# USB4 2.0 ENGINEERING CHANGE NOTICE FORM

**Title: TMU asymmetric correction wording simplification**  
**Applied to: USB4 Specification Version 2.0**

### (a). Section 7.2.3 Asymmetry Corrections

**Figure 7-7. Time Stamp Generation using TSNOS for a Gen 4 Link**

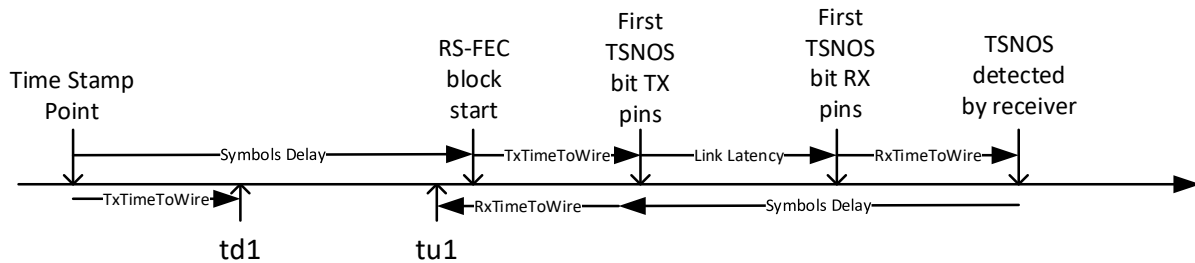
Figure 7-7 shows an example of how a Downstream Facing Port and an Upstream Facing Port use the TSNOS to generate time stamps for a Gen 4 Link.
